**ISSUE:** Permit to Demolish/Capsulate (partial) and Certificate of Appropriateness for alterations

**LOCATION:** Old & Historic Alexandria District  
1201 East Abingdon Drive

**BAR#2025-00035 & BAR#2025-00036 OHAD**  
**1201 E Abingdon Drive**

## CERTIFICATE OF APPROPRIATENESS AND DEMOLITION PERMIT APPLICATION *BAR Review #4*

BRICK COLOR

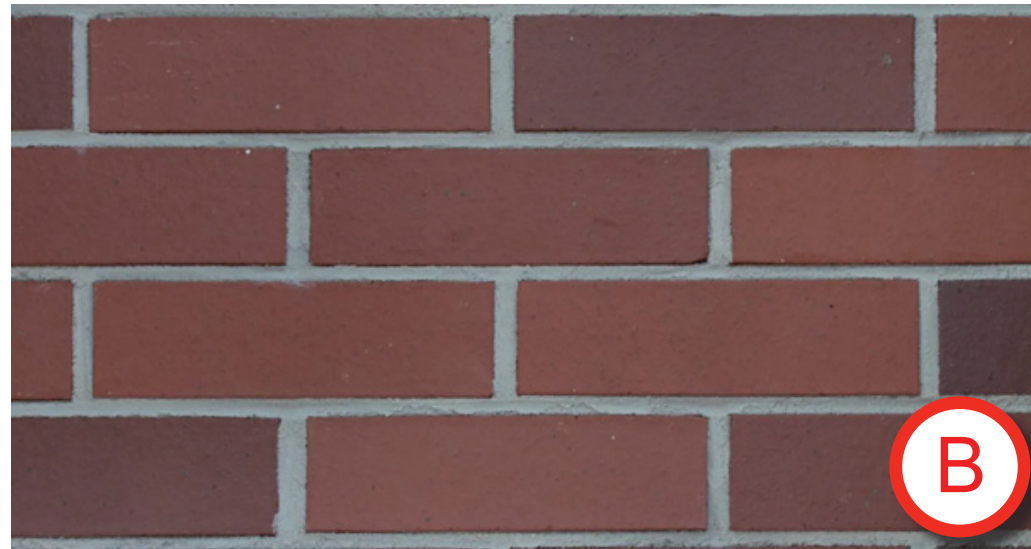
1 The light brick color creates too much contrast with the existing office building and the darker-colored brick within the window bays of the addition, and is not complementary to the adjacent red brick buildings.

After reviewing the brick tones of the surrounding townhomes and existing office building, we've selected a warmer brick option that complement the streetscape's color palette.

## VERTICALITY AND FLATNESS

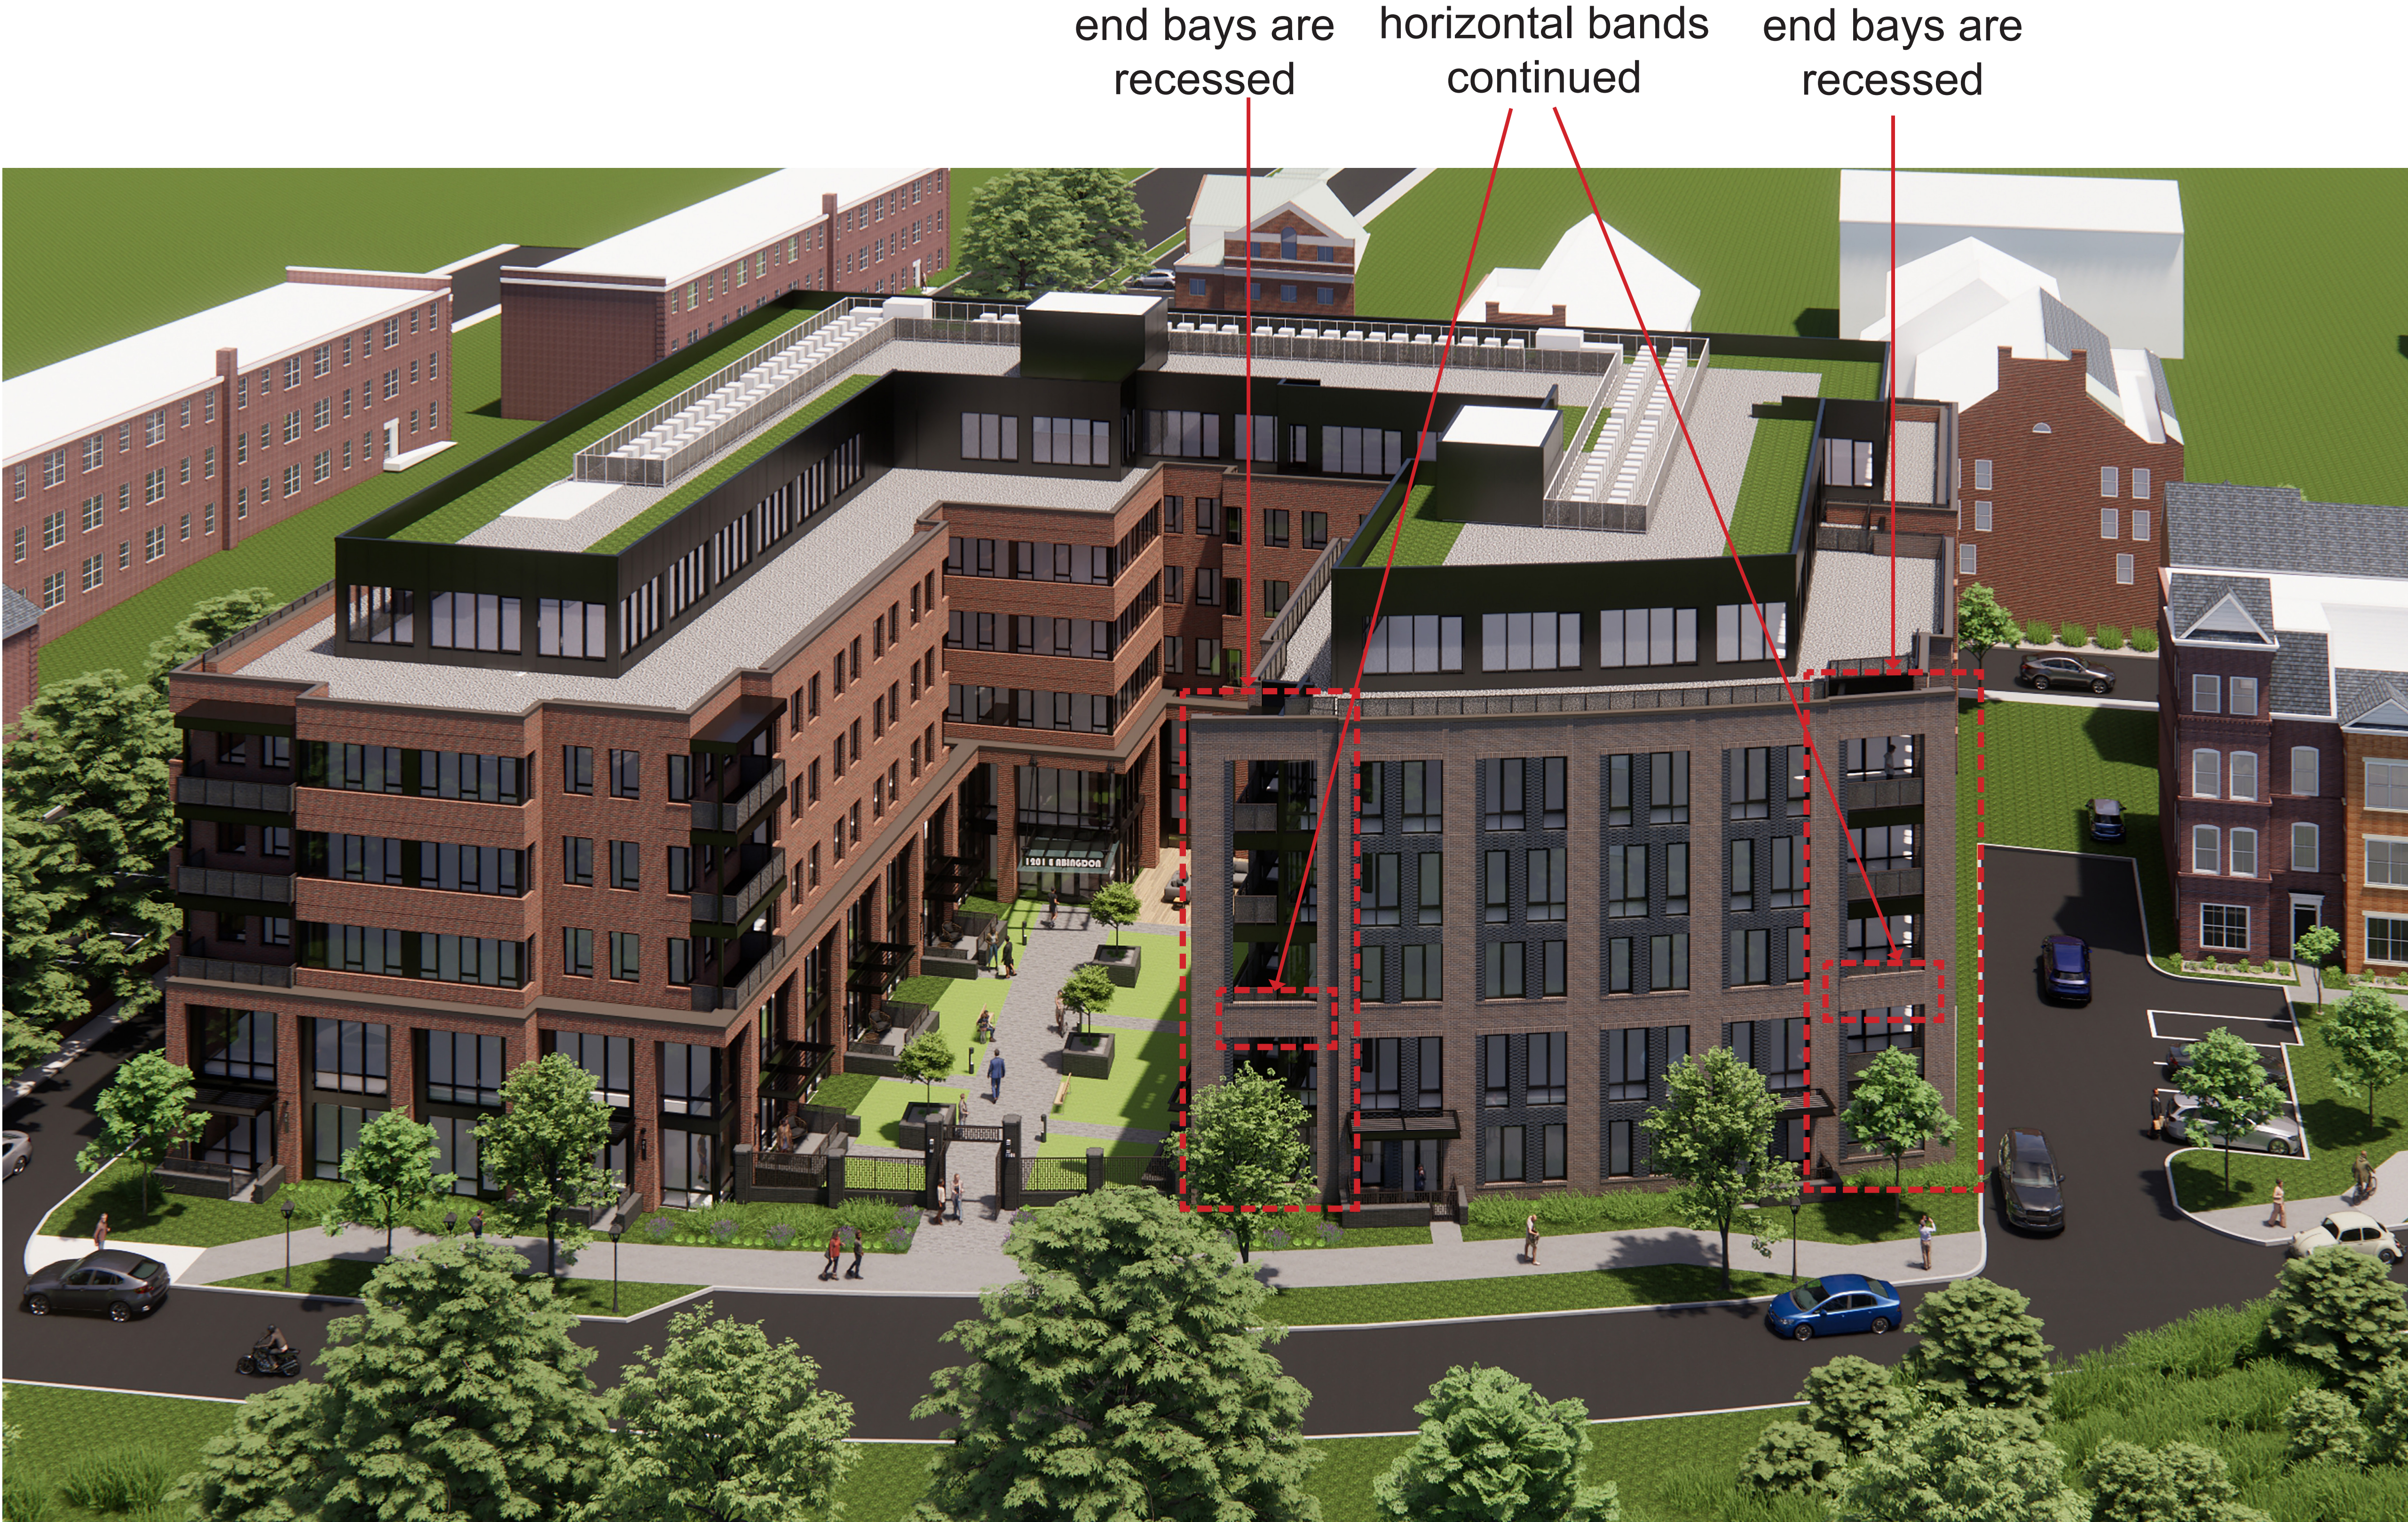
Minimize the verticality and strength of the addition.

To minimize the verticality of the new addition and address the appearance of unsupported piers, we've extended the horizontal element through the outer bays, ensuring that the outermost columns are visually and structurally supported.

To soften its presence and reduce its perceived mass, we've set back the two end bays by 8 inches, breaking the Western facade into three distinct segments.
